# UNITED STATES PATENT AND TRADEMARK OFFICE

APPLICATION NO.	FILING DATE	FIRST NAMED INVENTOR	ATTORNEY DOCKET NO.	CONFIRMATION NO.
10/510,384	10/05/2004	Andre Lechot	PUS-P001-031 (1.P566.31)	6469
51184 7590 12/08/2008 MOETTEL & ASSOCIATES SARL ST. LEONHARDSTRASSE 4 ST. GALLEN, CH-9000 SWITZERLAND			EXAMINER ARAJ, MICHAEL J	
			ART UNIT 3775	PAPER NUMBER
			MAIL DATE 12/08/2008	DELIVERY MODE PAPER

<b>Office Action Summary</b>	<b>Application No.</b> 10/510,384	<b>Applicant(s)</b> LECHOT ET AL.	
	<b>Examiner</b> MICHAEL J. ARAJ	<b>Art Unit</b> 3775

## **DETAILED ACTION**

**Figure 1 (Modified from '380)**

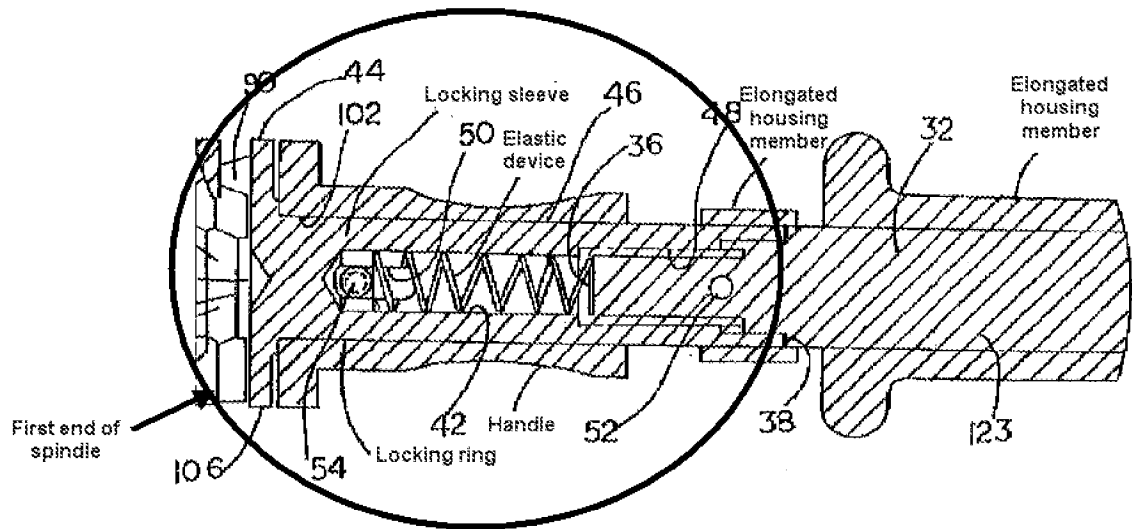
Salyer et al. disclose an elongated surgical reamer spindle, e.g. 10, having first and second ends and a central housing enclosing a drive train and comprised of at least two elongated housing members (see figure 1 below) a locking ring (46), an elastic

device (58), a locking sleeve (18), having a handle (24), and recesses, and a surgical reamer, e.g. 78 (see figures 1-19).

Applicant's arguments filed September 15, 2007 have been fully considered but they are not persuasive. Applicant argues that Salyer et al. does not disclose at least two elongated housing members. Figure 1 above, taken from Salyer et al., shows two elongated housing members.
